HARDIN 11 Industry Dr. Palm Coast, FL 32137 MARINE 386-445-2500 / FAX 386-445-1122

PART NO. 420-913222

DIFFERENCE BETWEEN GENERATIONS 1 & 2

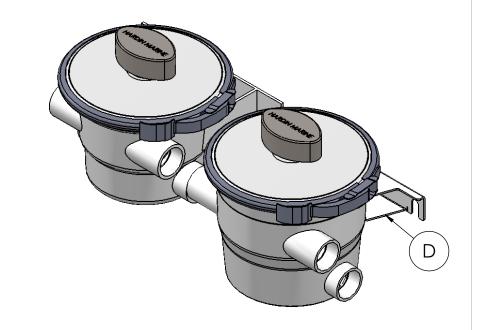
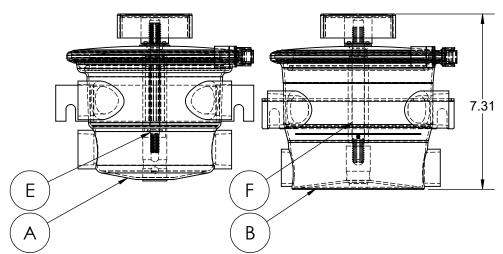
- 1) GENERATION 1 HAS A DOMED BOTTOM, FIG, A, GENERATION 2 HAS A FLAT BOTTOM, FIG. B.
- 7.31 2) GENERATION 1 MOUNTING BRACKET HAS 3 FLAT BRACES, FIG. C. GENERATION 2 HAS A CHANNELED FORMED BRACKET, FIG. D.
 - 3) GENERATION 1 USED A \emptyset 3/8 SHAFT, FIG. E. GENERATION 2 USES A \emptyset 1/2 SHAFT, FIG. F.
